LINCOLN-ELIOT ELEMENTARY SCHOOL

DRC MEETING

09 AUGUST 2023

DRC REVIEW COMMENTS & DESIGN TEAM RESPONSES

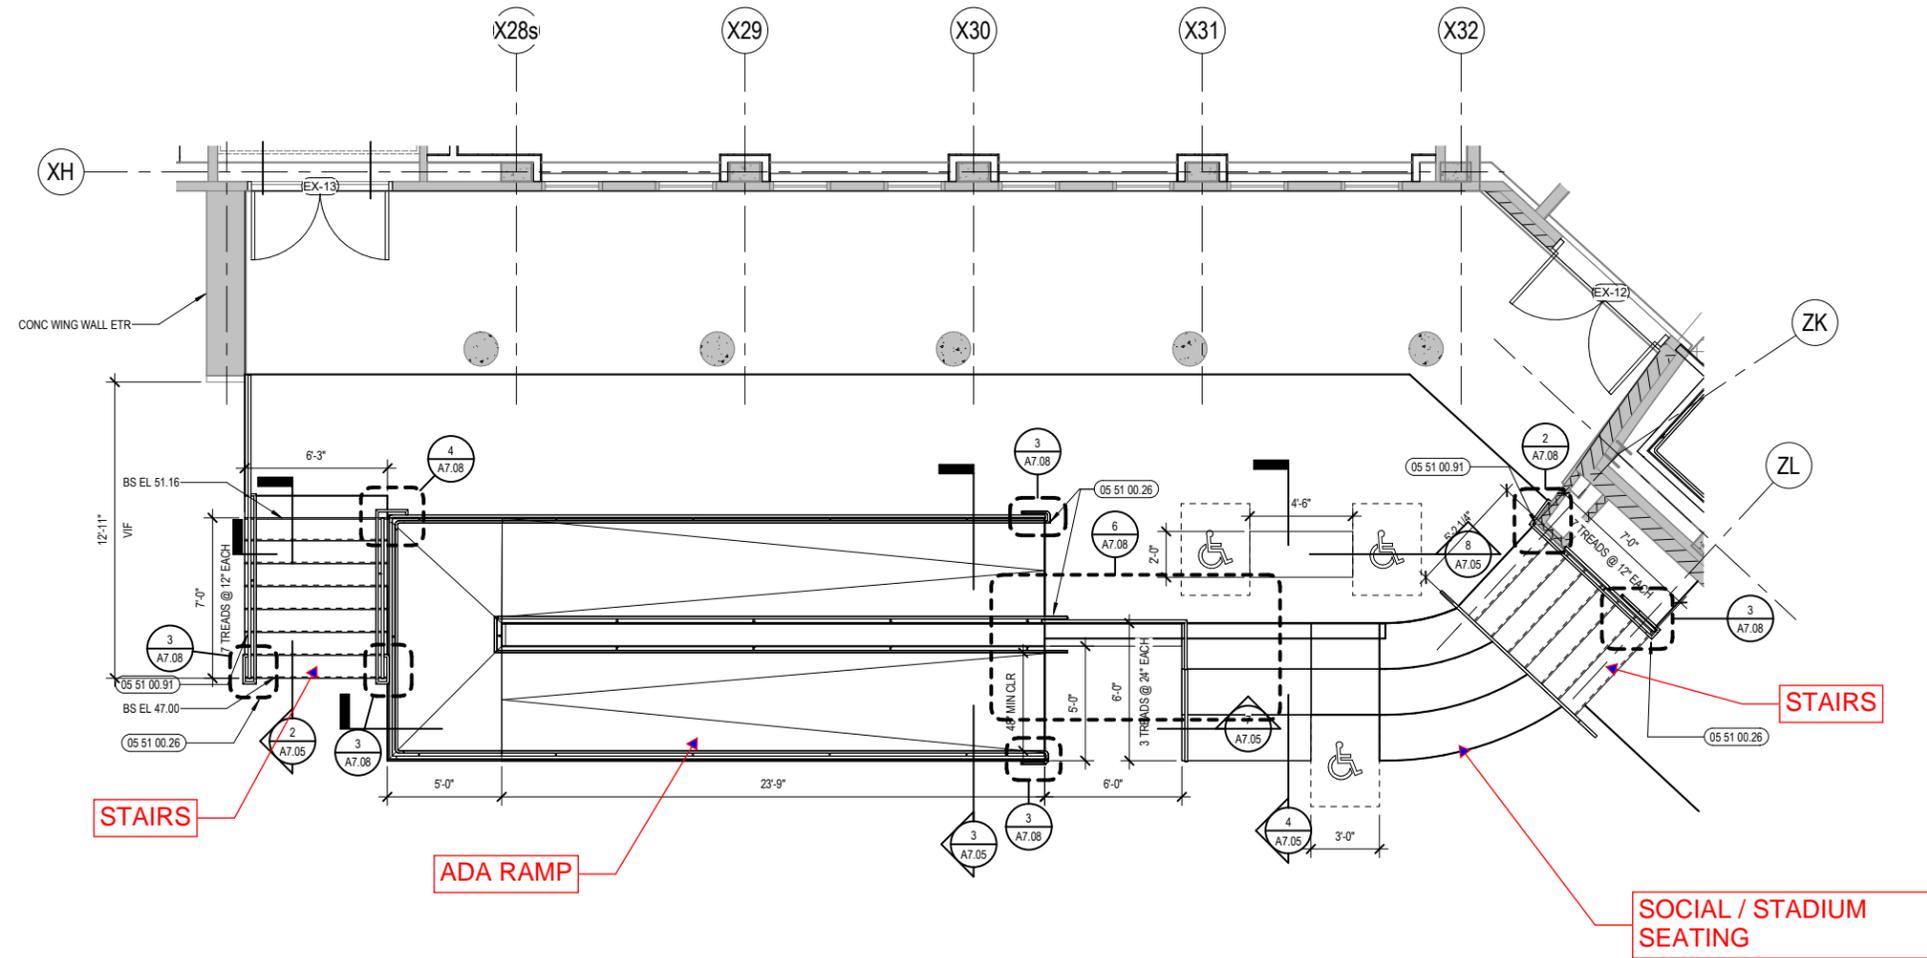
33	Landscape	SingNing Kuo	L2.01 Stairs at Cafeteria exterior	Rotate the stairs to accommodate people coming from the lower walkway	AST - Adjusting the location of the stairs and will be reflected in final CDs.
34	Landscape	SingNing Kuo	L2.01 Benches on cross site walkway	Locate 2 benches to the other side of the walkway for a better view down to the field	AST - Benches will remain on the field side to avoid constructing a retaining wall on the east side of the walkway where the grade is sloping upward toward the playground.
35	Landscape	SingNing Kuo	L2.02 Walnut Park pollinator garden	Is it possible to make the shape a bit more interesting?	AST - Will adjust the shape of the pollinator garden and will be reflected in final CDs.
